## HISTORIC PRESERVATION COMMISSION STAFF REPORT

Address: Lot 19, Block 4, Connecticut Avenue      Meeting Date: 3/26/97  
Resource: Kensington Historic District      Review: HAWP  
Case Number: 31/6-97C      Tax Credit: No  
Public Notice: 3/12 /97      Report Date: 3/19/97  
Applicant: Mark Raymond (Anthony Segreti, Agent)      Staff: Robin D. Ziek  
PROPOSAL: Construct new house w/ garage      RECOMMENDATIONS:  
Approval w/ Conditions

**a victorian style house in historic kensington**  
 Lot 19, block 4, R.B. Detrick's Subdivision  
 Kensington MD.

House, garage and driveway locations,  
Lot 19, Block 4, R.B. Detrick's Subdivision

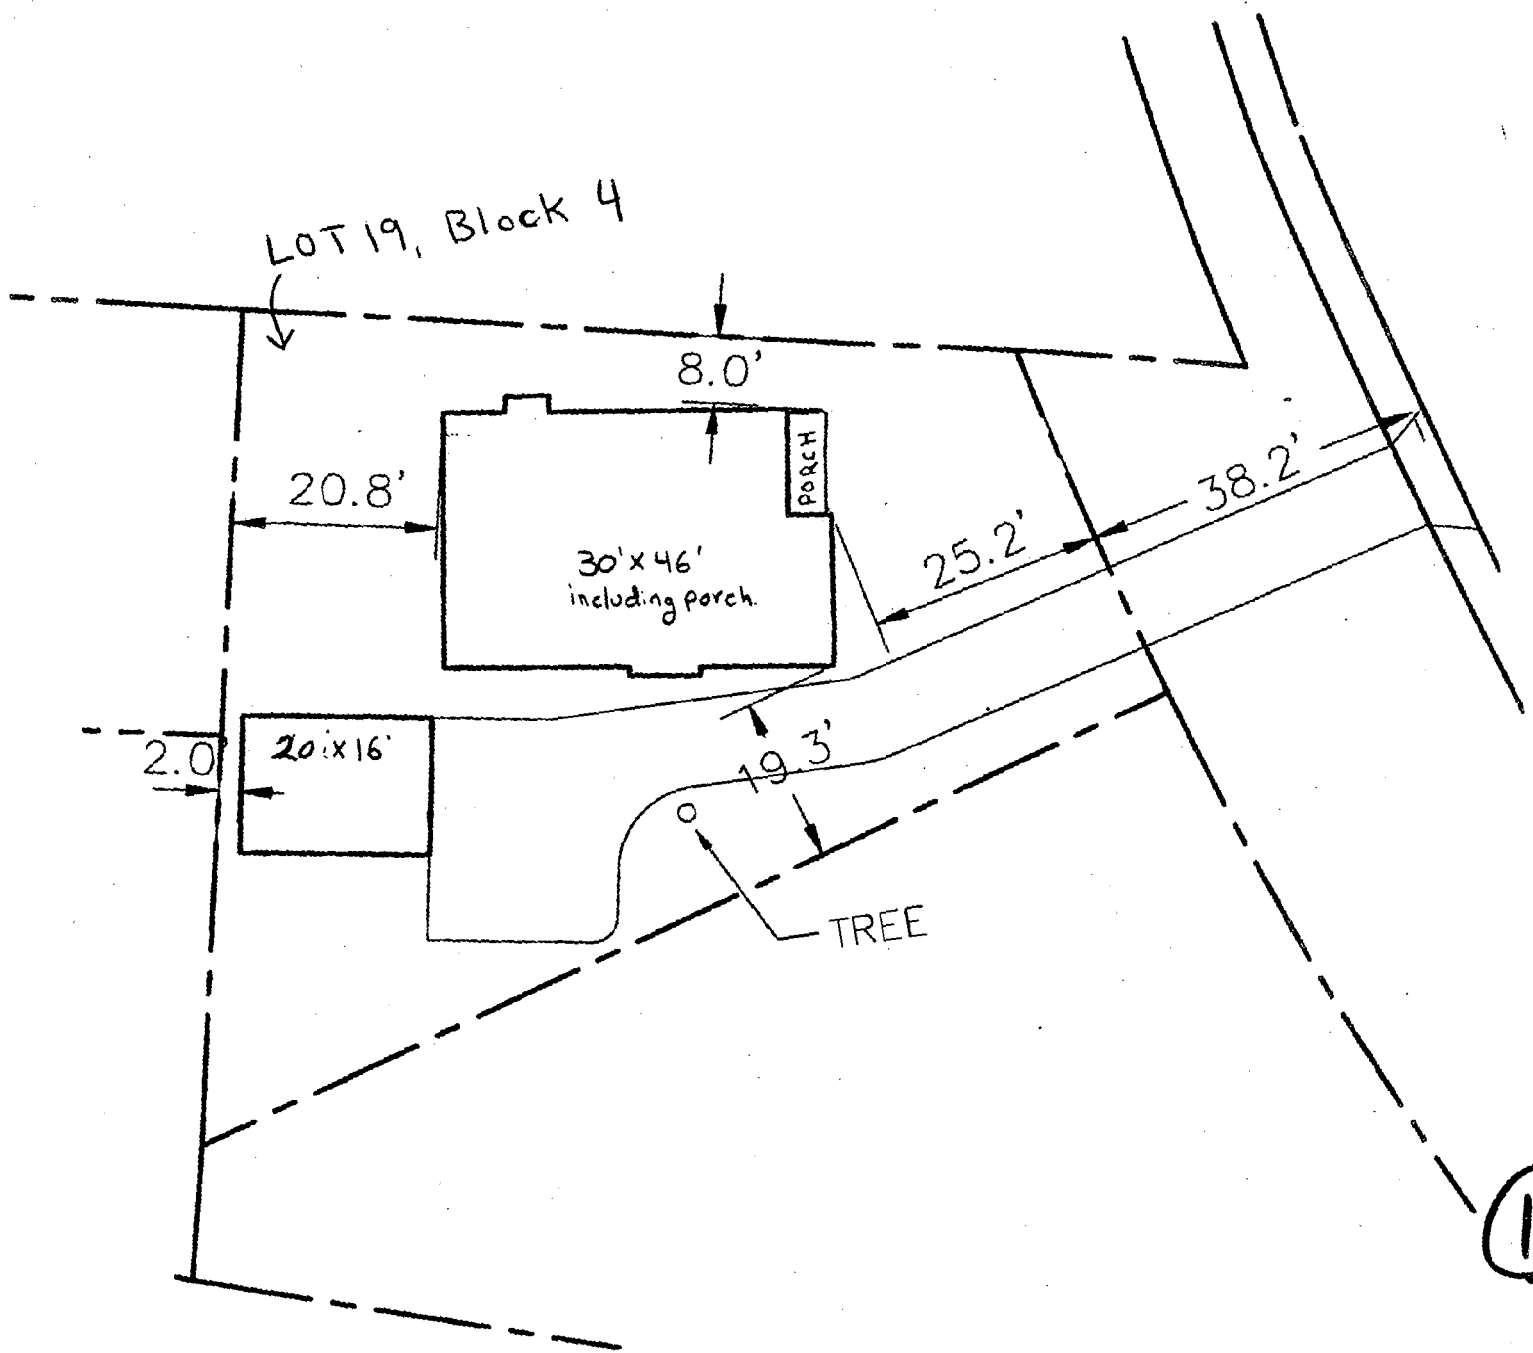
The proposed new house meets a 25' set back from the Connecticut Avenue right-of-way, which is 38' from the existing roadway. The new house will therefore be set 58' from the existing sidewalk. This is in line with the existing day care building, and will therefore maintain a consistent street edge along this block, even though this is much deeper than recommended by the Vision of Kensington. The footprint of the proposed house (30' x 46', or 1380 sf.) would provide a 20% lot coverage. With the garage (320 sf), the applicant proposes a total lot coverage of 25%.

Trees on Lot

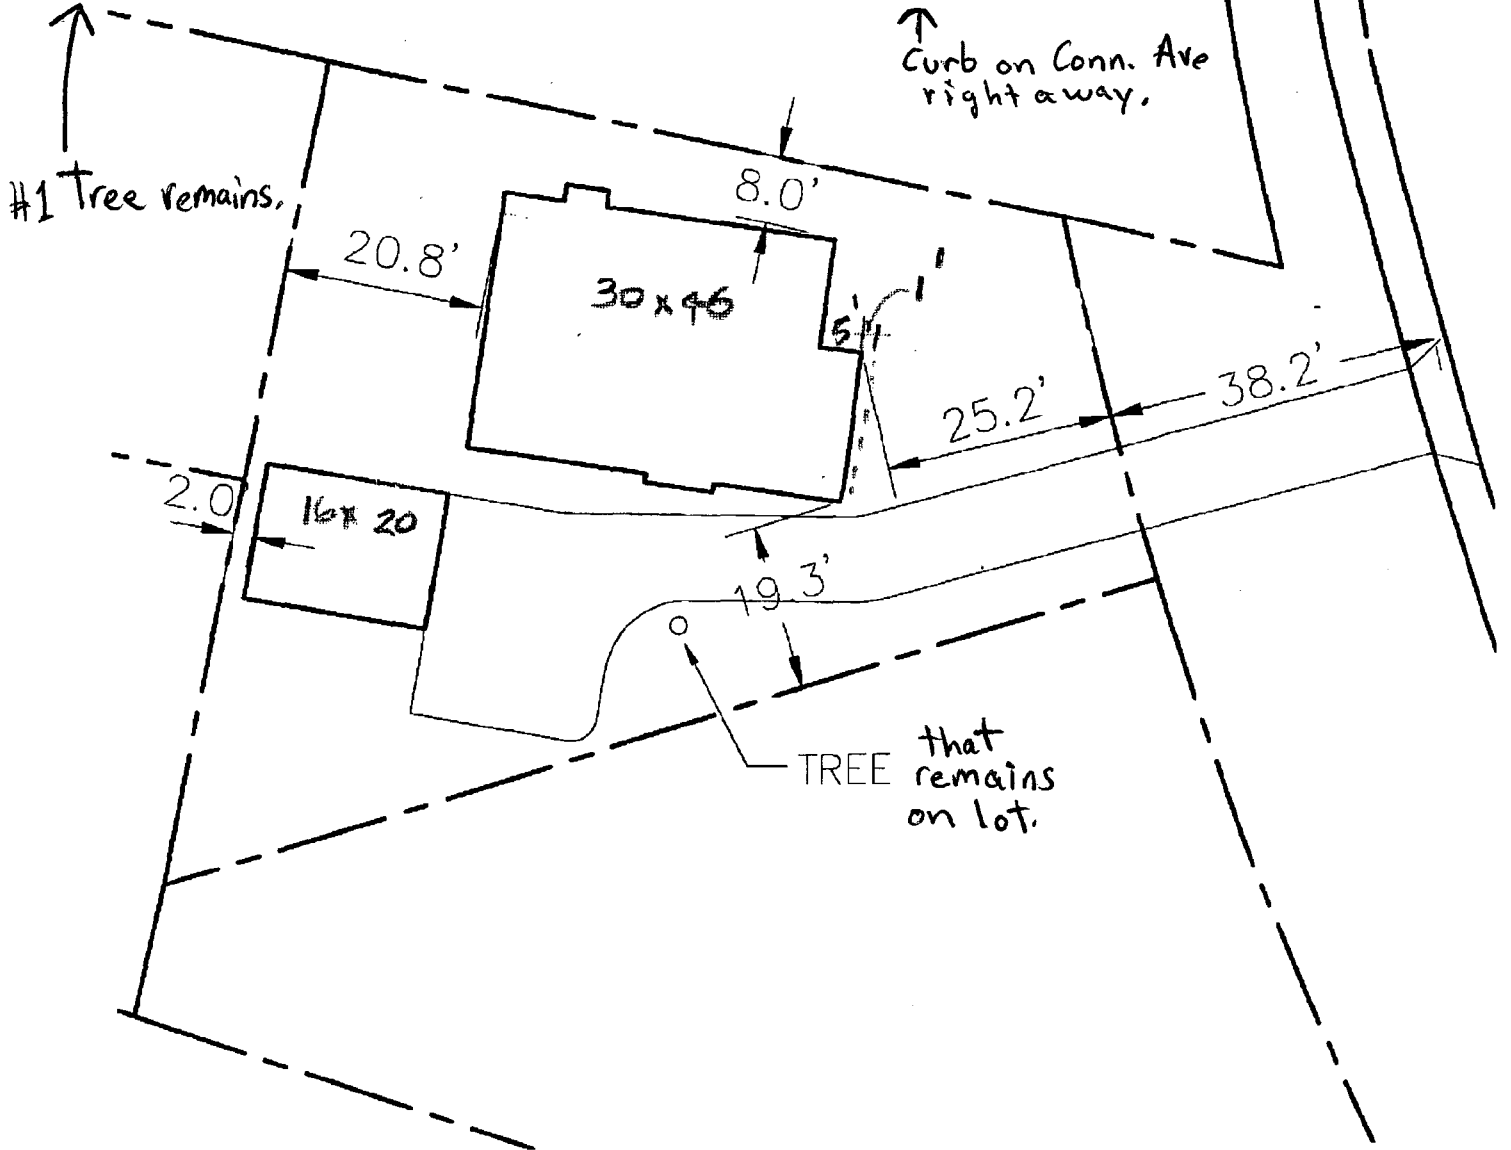
← Necessary removal of tree #2

8 NORTH GARAGE ELEVATION  
SCALE 1/8" = 1'-0"

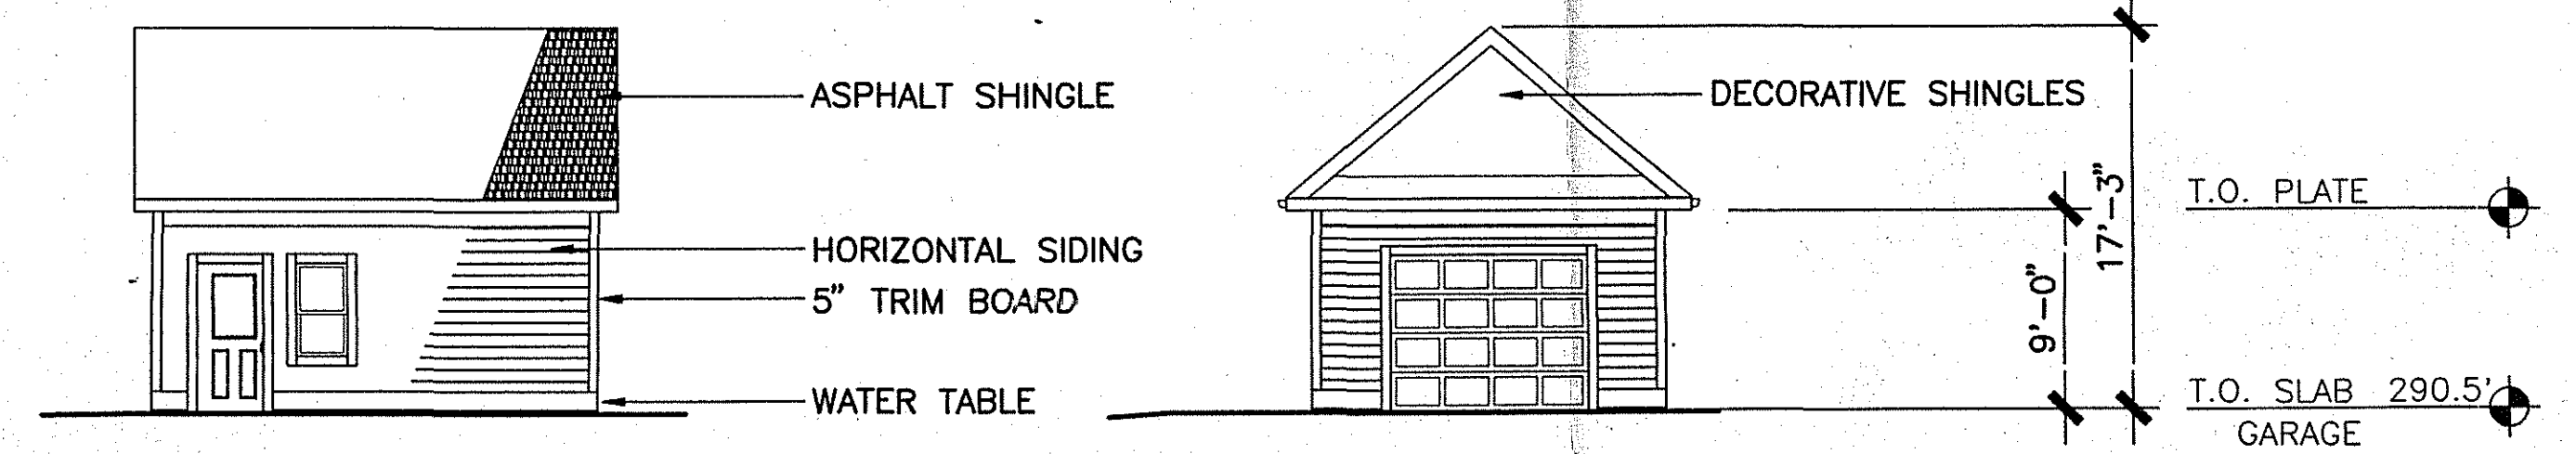
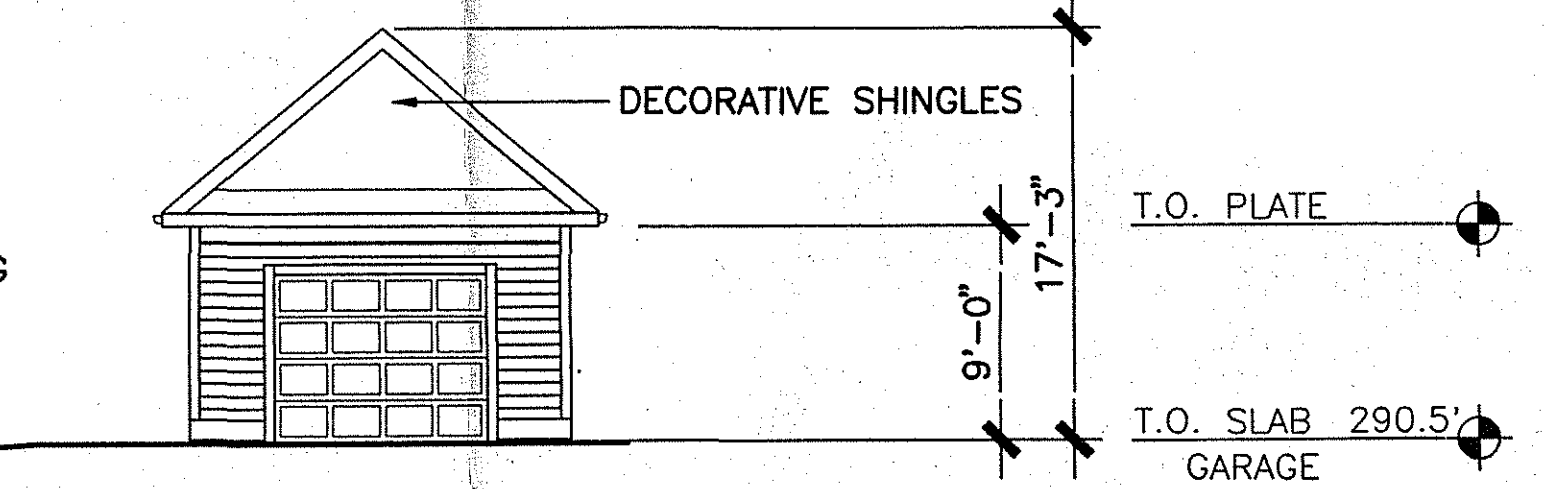
The single-car garage would measure 16' x' 20'. It would be one-story frame building with wood clapboard and shingles for siding to match the house. The drawing doesn't specify, but staff feels that a single-car garage door is appropriate, and would measure no more than 9' in width. The garage would be painted to match the house.

X   Approved with Conditions: ① Chimney to be faced with brick, and extend to foundation @ grade ; ② Foundation to be poured concrete block or smooth-faced poured concrete ; ③ Adequate tree protection to be undertaken for mesquite including root protection mat under driveway area, fencing before & after construction, fencing at diploma during construction, and driveway to be at least 2' away from tree, and a porous driveway material used in <sup>road</sup> proximity to tree ; ④ a single-car garage door no wider than 9' ; ⑤ a new tree shall be planted in front yard ; ⑥
